**PLANS AND DOCUMENTS
referred to in the PDA
DEVELOPMENT APPROVAL**

Approval no: DEV2022/1337

**RE: Technical Memorandum – Response to Further Issues Flooding Matters
PDA Development Application No. DEV2022/1337
15 Anderson Street, Fortitude Valley**

Figure 2: Proposed Ground Floor Plan – dated 10/11/23 (Source: Telha Clarke)

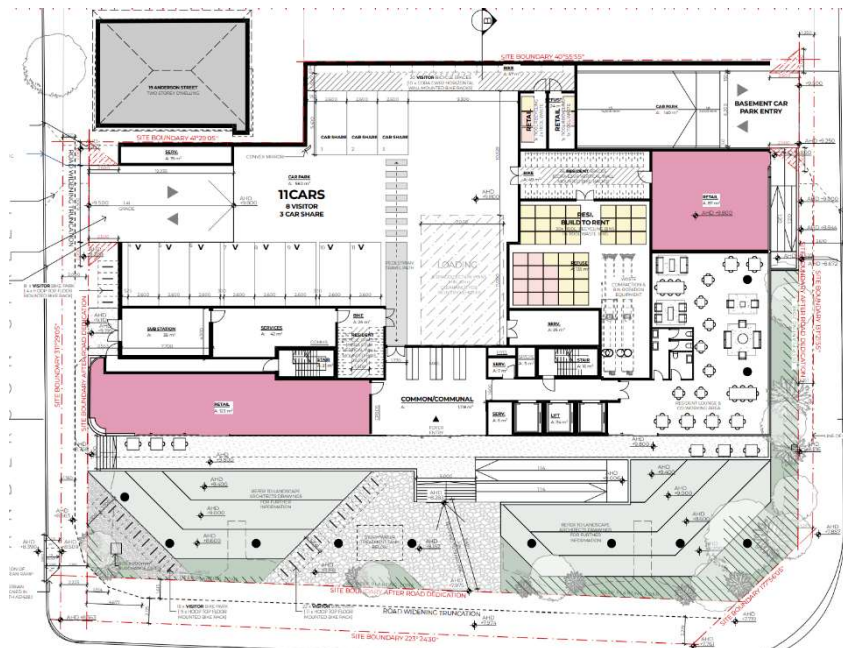
The proposed development's ground floor plan shown in Figure 2 below demonstrates an on-ground frontage and adjoining interface to Water Street, which will allow some level of additional overland flow conveyance and short-duration flood storage to occur during and up to all design overland flow flood events. Accordingly, this would quantitatively, retain or reduce the peak flood levels within and around the site.
